# Access Compliance Report

## Public Rights-of-Way

### (Curb Ramps)

Intersection ID: 52933	Main Street: EMORY_OAK_DR	Cross Street: WILLOW_OAK_POND_LN	Location: SE
ADA ID: 9ADBC67EC400	Ramp Type: Perp	Initial Pass/Fail: Fail	Overall Compliance: No
Codes/Mitigation Info/Possible Solution		Field Measurements/Component Compliance	
Severity Score: 10

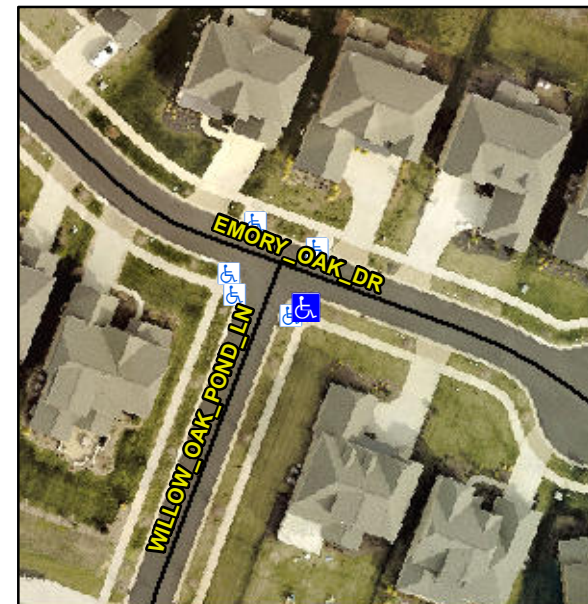
**Not Found, R304.5.1, R304.5.3**

Compliance	Description	Data	Compliance	Description	Data
N/A	Ramp Length (in)	97.0	Yes	Ramp Slope (%)	5.0
No	Ramp Width (in)	46.5	No	Ramp XSlope (%)	4.5
N/A	Flare Type LT	N/A	N/A	Flare Type RT	N/A
N/A	Flare Slope LT (%)	N/A	N/A	Flare Slope RT (%)	N/A
N/A	Flare Traversable LT?	N/A	N/A	Flare Traversable RT?	N/A
N/A	Landing Length (in)	N/A	N/A	DWS Provided?	N/A
N/A	Landing Width (in)	N/A	N/A	DWS Contrast?	N/A
N/A	Landing Slope (%)	N/A	N/A	DWS Length (in)	N/A
N/A	Landing X Slope (%)	N/A	N/A	DWS Full Width?	N/A
N/A	Landing Curb? (Y/N)	N/A	N/A	DWS Offset (in)	N/A
N/A	Shared Landing?	N/A			
N/A	Gutter Ponding?	N/A	N/A	Gutter Slope (%)	N/A
N/A	Gutter Lip Ht (in)	N/A	N/A	Gutter X Slope (%)	N/A
N/A	Painted X Walk1?	No	N/A	Painted X Walk2?	N/A
	X Walk 1 Direction	To N		X Walk 2 Direction	N/A
N/A	X Walk 1 Width (in)	N/A	N/A	X Walk 2 Width (in)	N/A
	X Walk 1 Slope (%)	5.0		X Walk 2 Slope (%)	N/A
	X Walk 1 X Slope (%)	3.2		X Walk 2 X Slope (%)	N/A

**Remove & Replace Entire Ramp.**
